Access Compliance Report

Public Rights-of-Way

Intersection ID: 44950	Main Street: WEAVERS_GLENN_PL	Cross Street: OLDCORN_LN	Location:	S
ADA ID: BDF5E88F71FA	Ramp Type: PerpDiag	Initial Pass/Fail: Fail	Overall Compliance: No	Severity Score: 22.5
Codes/Mitigation Info/Possible Solution		Field Measurements/Component Compliance

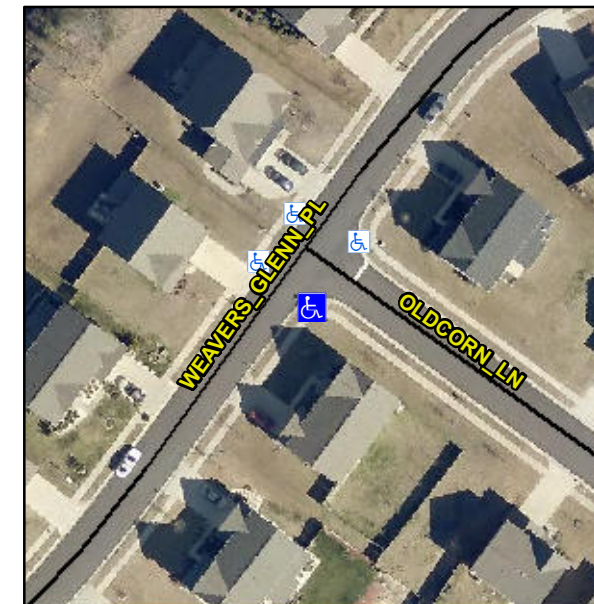
Not Found, R304.5.1, R304.2.2, R304.5.3

Compliance	Description	Data	Compliance	Description	Data
N/A	Ramp Length (in)	47.0	No	Ramp Slope (%)	8.5
No	Ramp Width (in)	47.5	No	Ramp XSlope (%)	4.6
N/A	Flare Type LT	N/A	N/A	Flare Type RT	N/A
N/A	Flare Slope LT (%)	N/A	N/A	Flare Slope RT (%)	N/A
N/A	Flare Traversable LT?	N/A	N/A	Flare Traversable RT?	N/A
N/A	Landing Length (in)	N/A	N/A	DWS Provided?	N/A
N/A	Landing Width (in)	N/A	N/A	DWS Contrast?	N/A
N/A	Landing Slope (%)	N/A	N/A	DWS Length (in)	N/A
N/A	Landing X Slope (%)	N/A	N/A	DWS Full Width?	N/A
N/A	Landing Curb? (Y/N)	N/A	N/A	DWS Offset (in)	N/A
N/A	Shared Landing?	N/A			
N/A	Gutter Ponding?	N/A	N/A	Gutter Slope (%)	N/A
N/A	Gutter Lip Ht (in)	N/A	N/A	Gutter X Slope (%)	N/A
N/A	Painted X Walk1?	No	N/A	Painted X Walk2?	No
	X Walk 1 Direction	To NE		X Walk 2 Direction	To NW
N/A	X Walk 1 Width (in)	N/A	N/A	X Walk 2 Width (in)	N/A
	X Walk 1 Slope (%)	6.1		X Walk 2 Slope (%)	6.8
	X Walk 1 X Slope (%)	3.2		X Walk 2 X Slope (%)	0.2

Remove & Replace Curb Ramp With Two New Directional Ramps or Equivalent.
